Rampion 2 Wind Farm

8.54 Applicant's Responses to Examining Authority's First Written Questions (ExQ1)

Application Reference: 8.54

Indicative Profile View of Basin P2

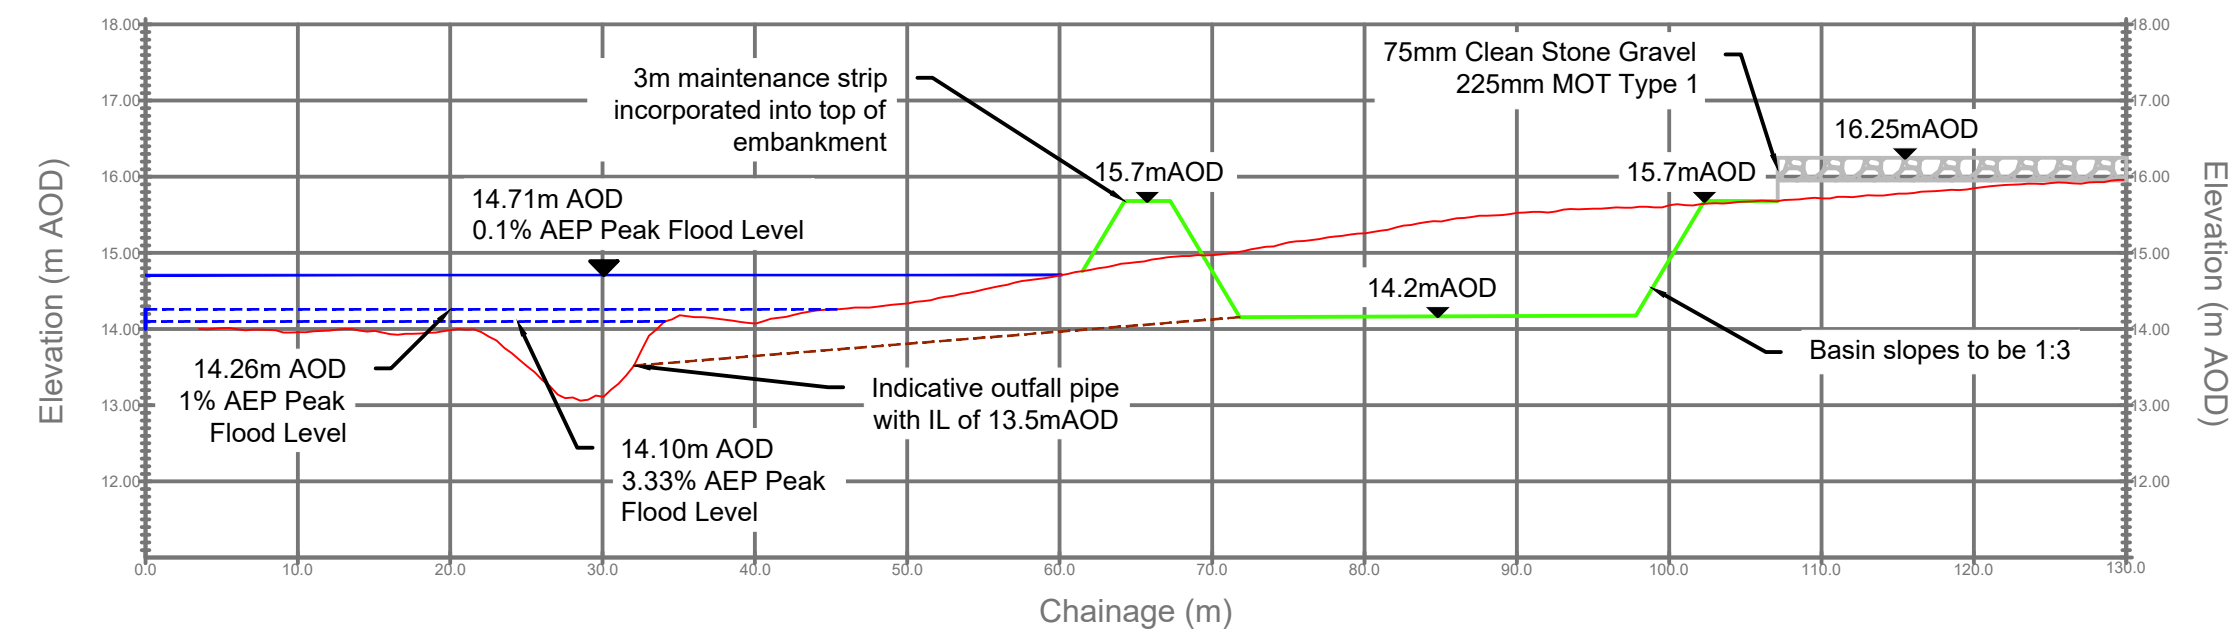
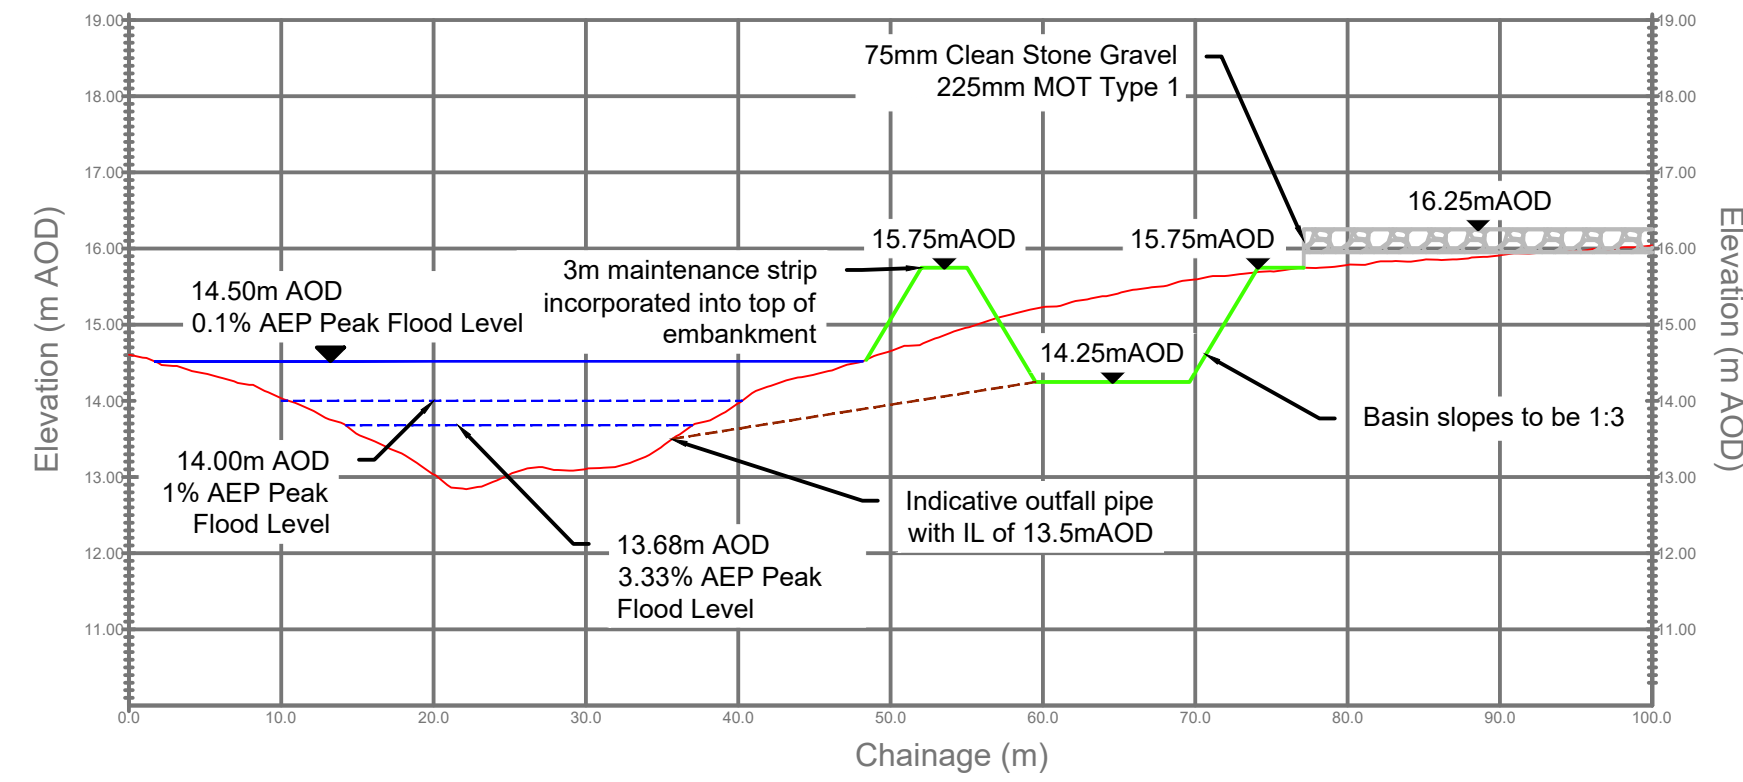
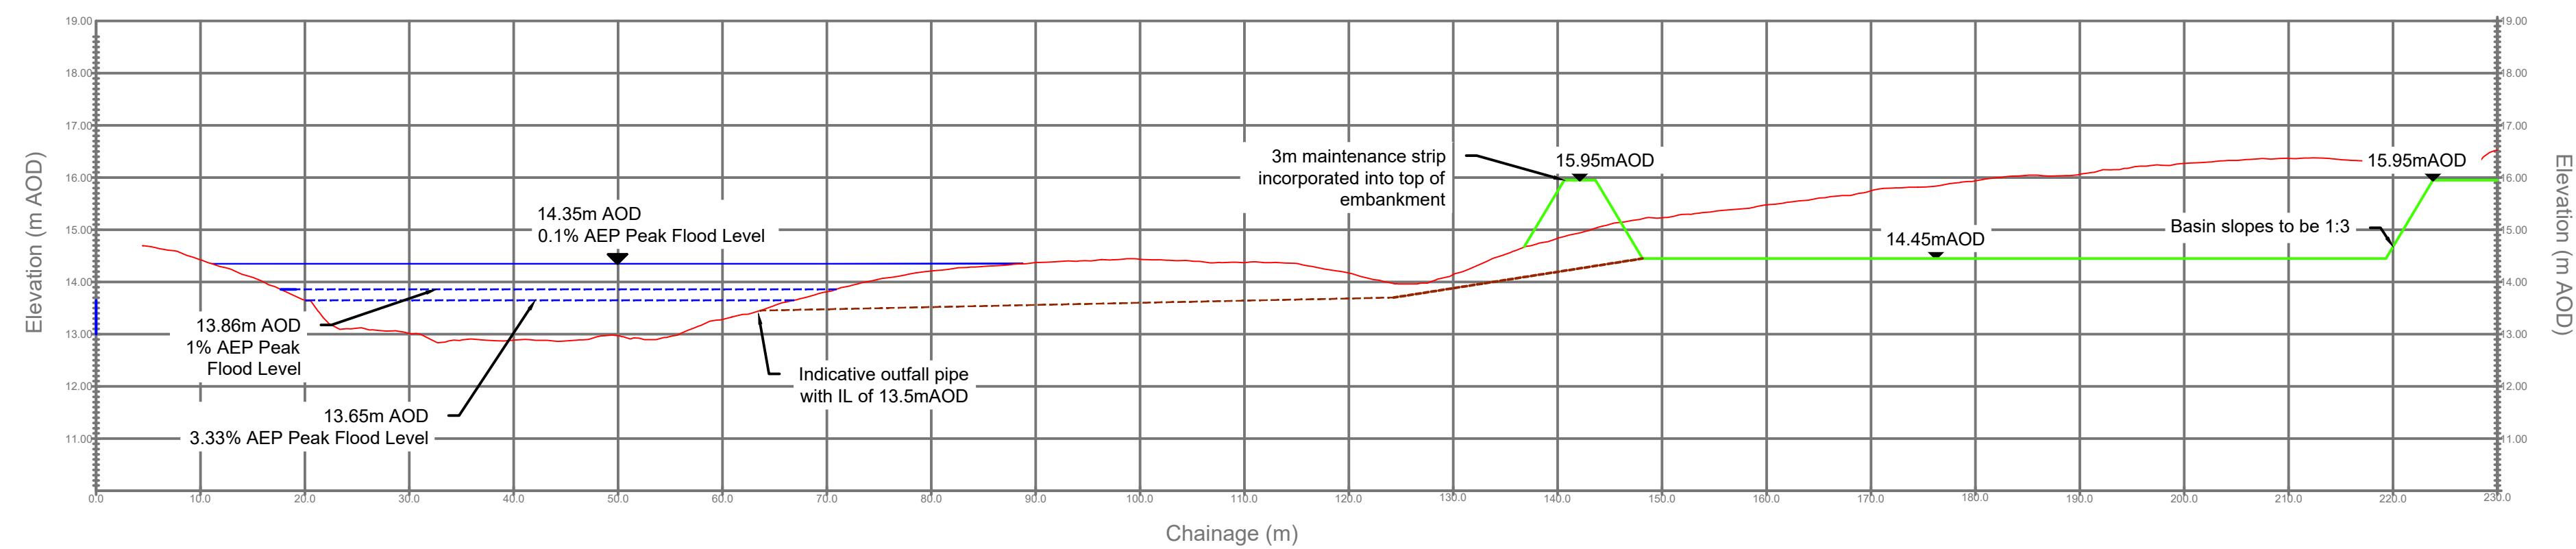
- 1.2.4 In order to assist in answering question FR1.2 to the level of detail requested (diagrams and calculations), the Applicant has commenced some of the initial drainage and hydraulic modelling tasks that will contribute towards the detailed design. However, the additional information provided should not be considered in any way to be part of the detailed design. Instead, the additional information seeks to further demonstrate that an appropriate solution to flood risk and drainage matters can be delivered at the detailed design stage, whilst adhering to the design principles set out in **Appendix 26.2: Flood Risk Assessment, Volume 4** of the ES **[APP-216]** and **Outline Operational Drainage Plan [APP-223]**, including (as requested in part b of this question), to ensure no net loss of floodplain storage and to maintain greenfield runoff rates.

- 1.2.26 To support the assertion that sufficient space is available (to provide the required attenuation storage to maintain runoff at greenfield rates, without any loss of floodplain storage), indicative cross sections of the basins in the vicinity of the ordinary watercourse, and indicative peak flood levels in the watercourse have since been produced and provided in **Annex A** (as referred to in answering **FR1.2 part a**). These show the estimated 0.1% AEP RoFSW peak flood level (along with the 1% AEP and 3.33% AEP levels) at each basin, in addition to indicative basin configurations accounting for side slopes and maintenance widths, and the indicative platform level. As demonstrated in the response to **FR1.2 part a**), basins of sufficient capacity can be delivered within the available space between the southern boundary of the onshore substation footprint and the 0.1% AEP flood extent, in accordance with the indicative design parameters stated in Table 2-2 of the **Outline Operational Drainage Plan [APP-223]**. This has further been supported by the Causeway Flow modelling as described in the Applicant's response to **FR1.2 Part a**) above, to demonstrate that there is sufficient attenuation volume available within the basins to maintain runoff at greenfield rates, without any loss of floodplain storage even considering the impacts of a severe flood event within the watercourse south of the onshore substation site.

Figure 1 Flood map for planning: Oakendene onshore substation site

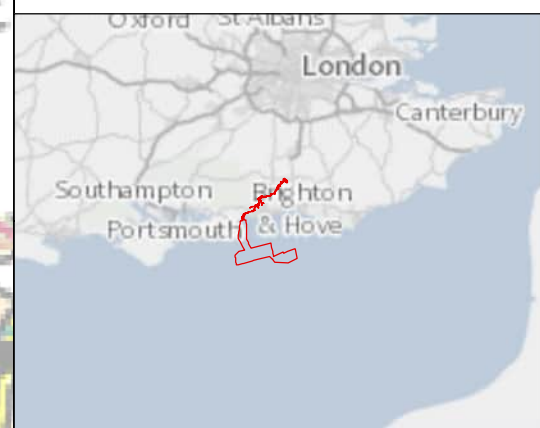
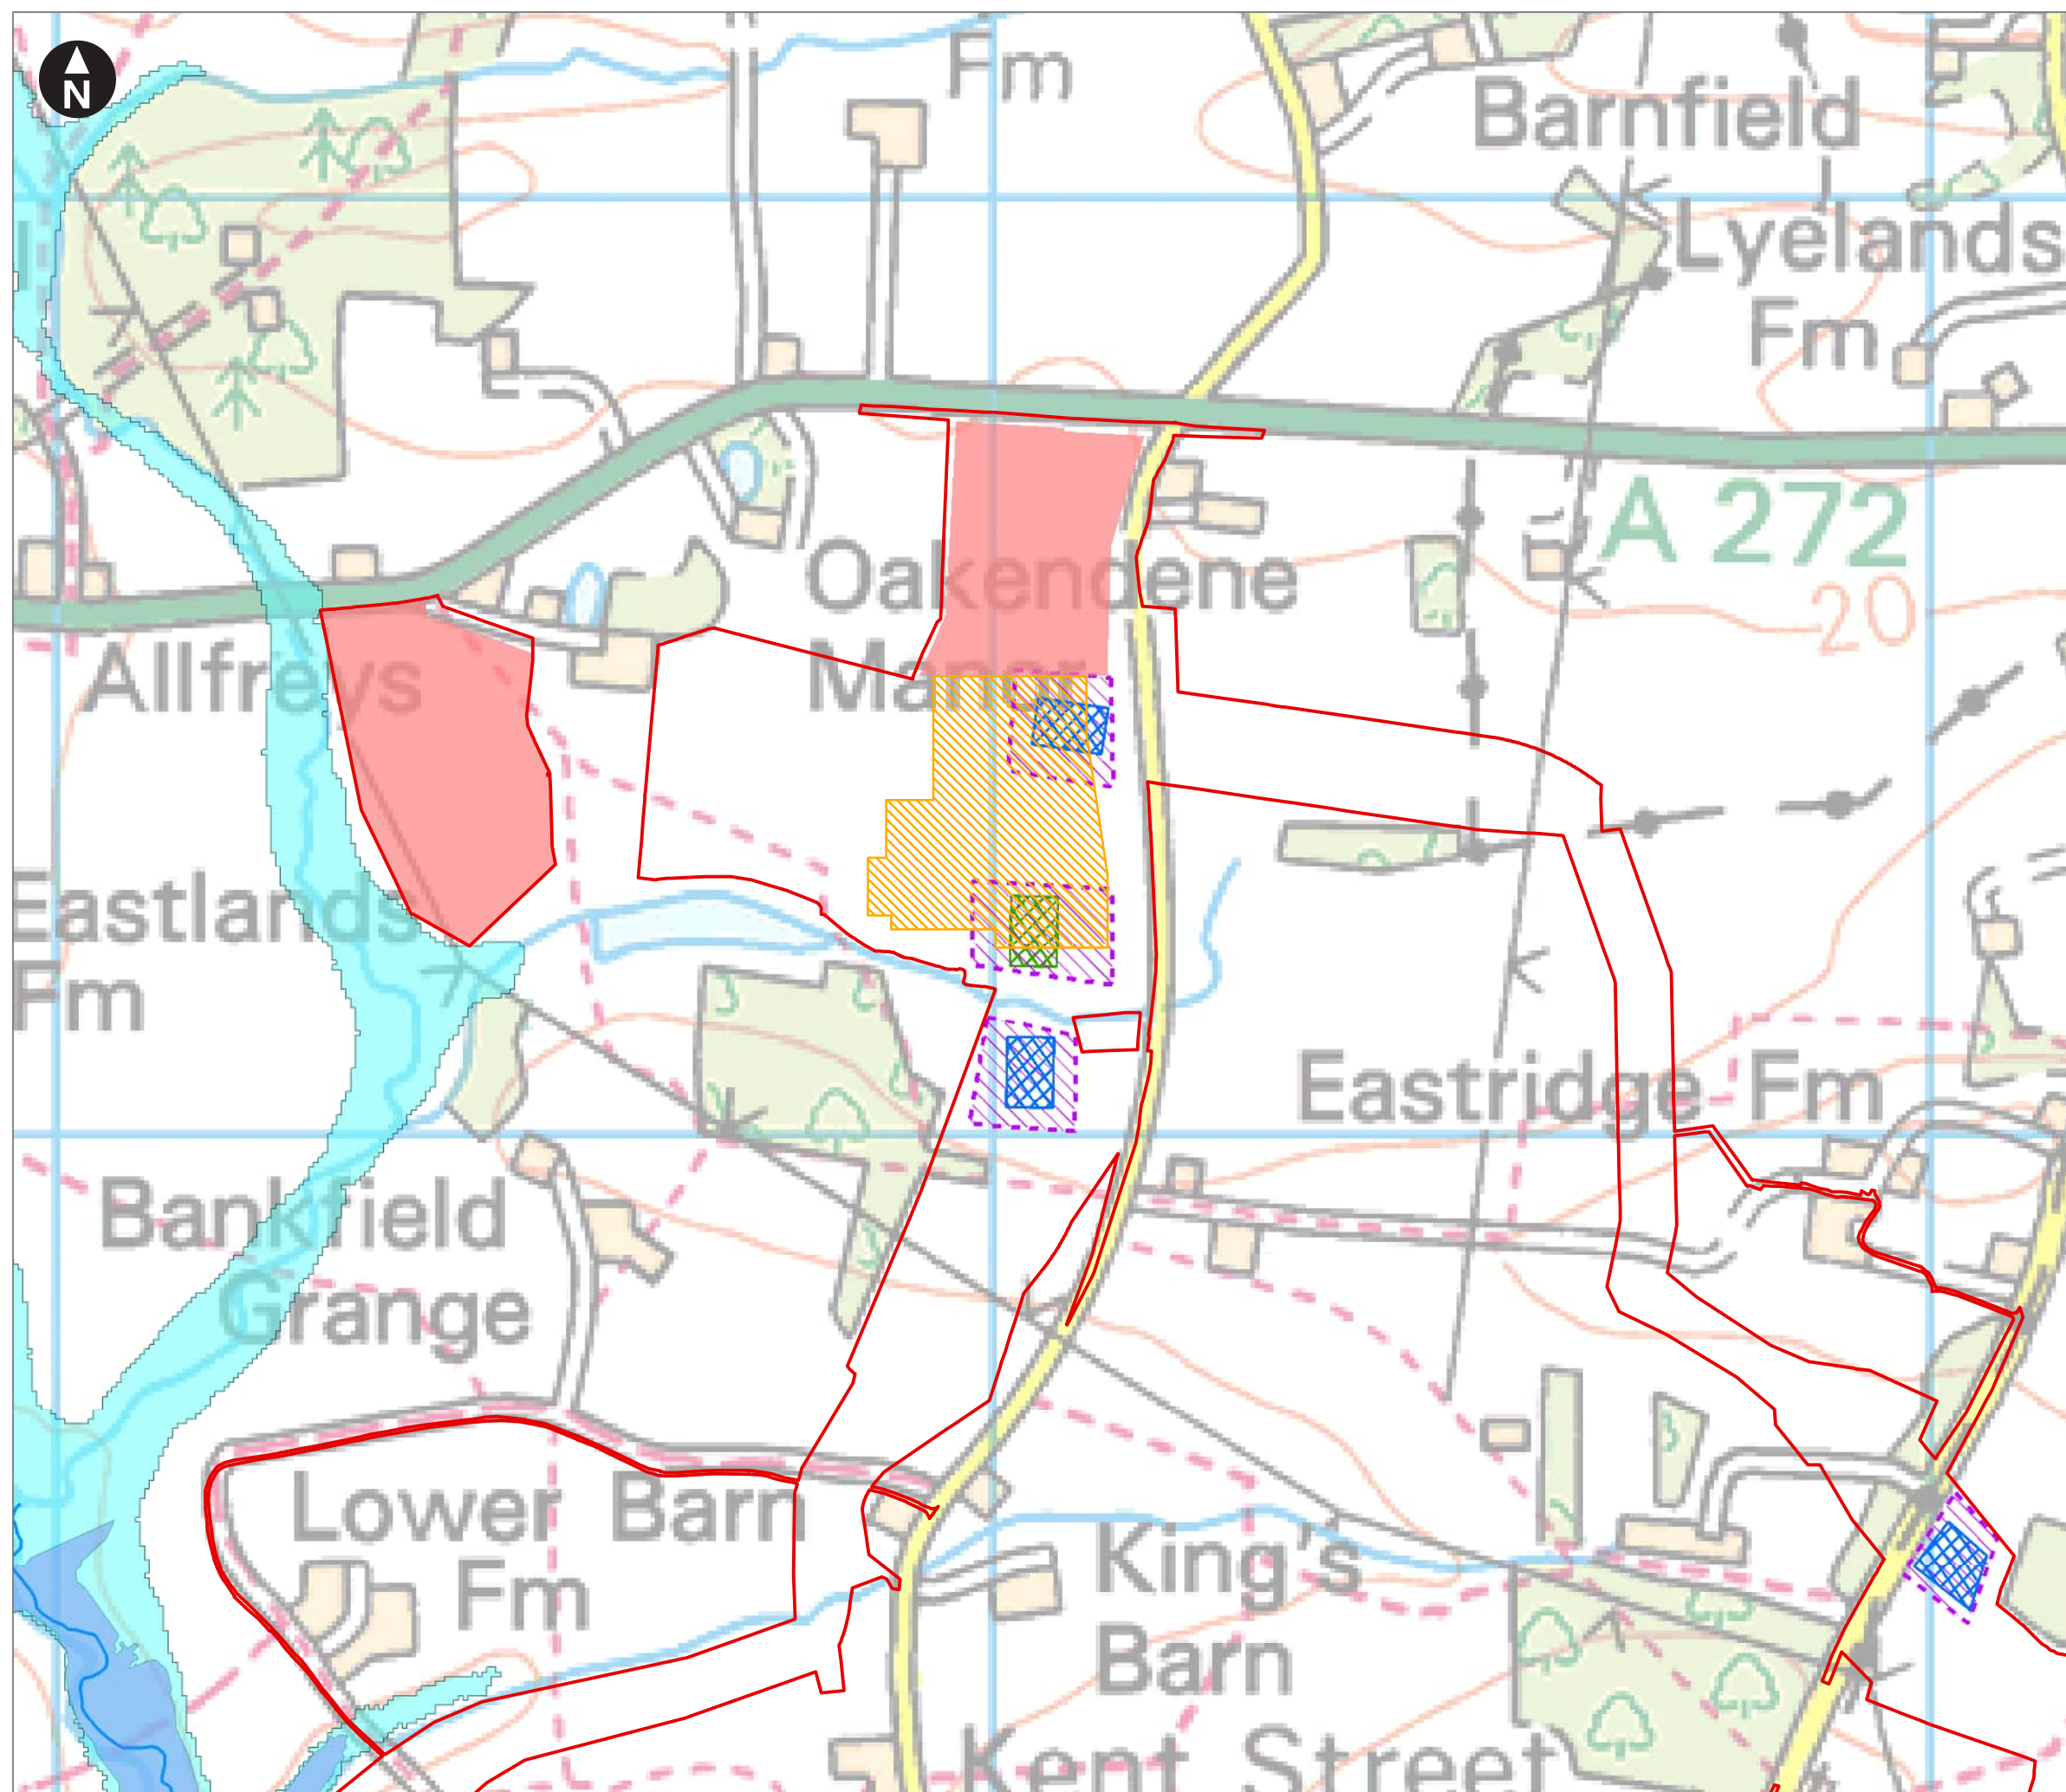
*“Flood Risk at the Proposed Substation site at Oakendene
The Flood Risk Assessment [APP-216] states that the proposed substation site at Oakendene is within Flood Zone 1 and this was confirmed by the Applicant during questioning at ISH1 [EV3-001] whilst Mr Smethurst believes the site falls within Flood Zone 3 [REP1-115]. Figure 26.2.2 in the Flood Risk Assessment [APP-216] shows which areas of the whole of the Proposed Development fall within various flood zones in Figure 26.2.2 but the ExA considers it difficult to see any detail at this scale for the proposed Oakendene substation site*

- 2.2.3 As requested, a new zoomed in plan for the onshore substation site at Oakendene and its surrounding area is included as **Figure 1** in **Annex B** of this Appendix. As shown in **Figure 1**, the onshore substation site at Oakendene falls entirely within Environment Agency Flood Zone 1, which is defined as '*land having less than a 1 in 1,000 annual probability of river or sea flooding*'. Flood Zone 1 is the zone considered to be at lowest probability of flooding from rivers and the sea (compared to Flood Zones 2 and 3).
